# **Mobile Intel<sup>®</sup> Pentium<sup>®</sup> II Processor Specification Update**

Release Date: May 2002

Order Number: 243887-040

The Mobile Pentium<sup>®</sup> II processor may contain design defects or errors known as errata which may cause the product to deviate from published specifications. Current characterized errata are documented in this Specification Update.

Old Mobile Pentium® II Processor in Mini-Cartridge Package Label with Supplier Matrix Mark

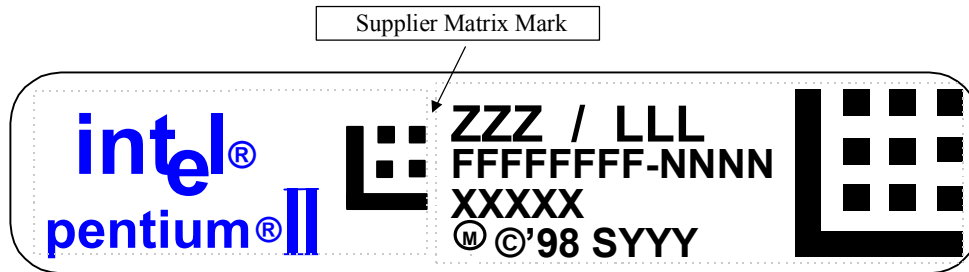
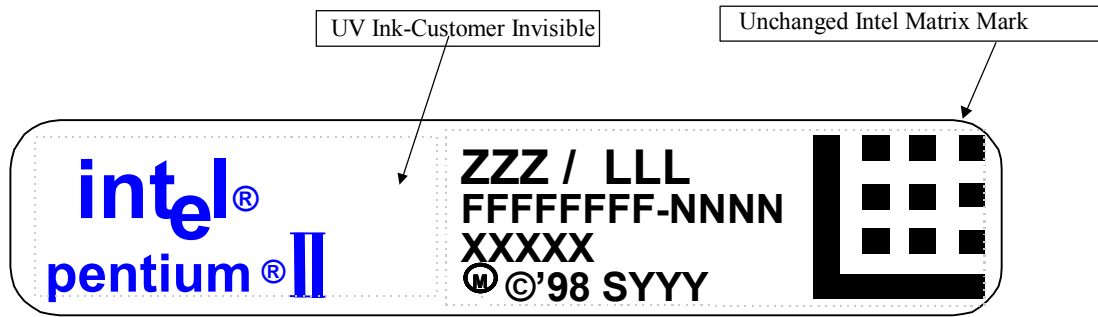
New Mobile Pentium® II Processor in Mini-Cartridge Package Label with Supplier Matrix Mark Removed

Figure 1. TAP Gageable Thread Clarification

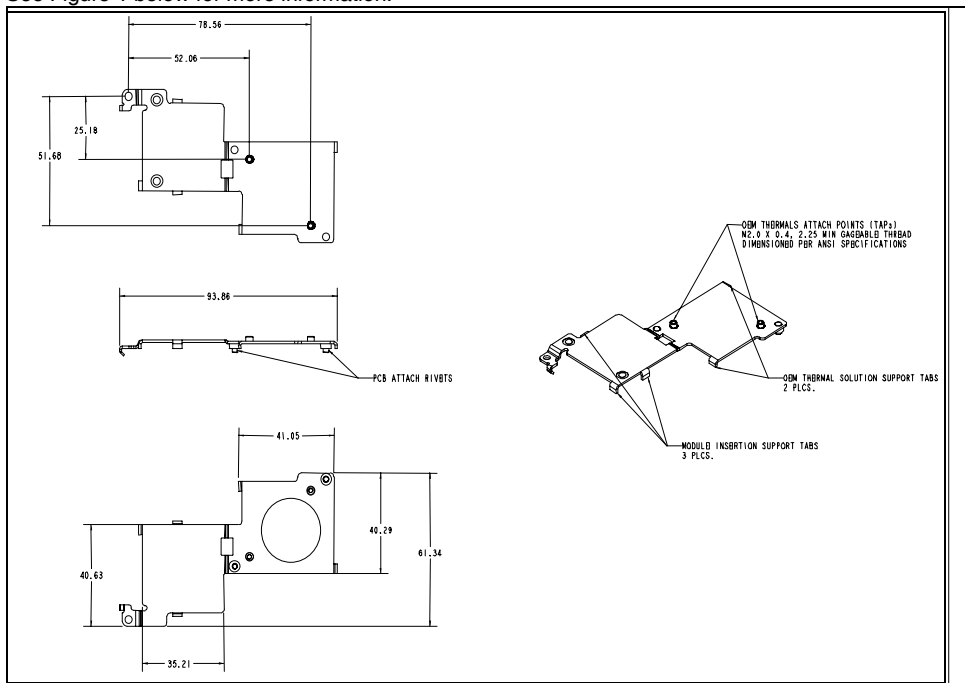
In the *Intel® Pentium® II Processor Mobile Module : Mobile Module Connector 1 (MMC-1)* and the *Intel® Pentium® II Processor Mobile Module : Mobile Module Connector 2 (MMC-2)* datasheets (Order Numbers 243667 and 243668, respectively), the thermal attach point (TAP) gageable thread specification was not clearly identified in Figure 14, of Section 5.2. The following is the TAP clarification:

OEM Thermal Attach Points (TAPs) M2.0 x 0.4, 2.25 min gageable thread dimensioned per ANSI specification.

See Figure 1 below for more information.
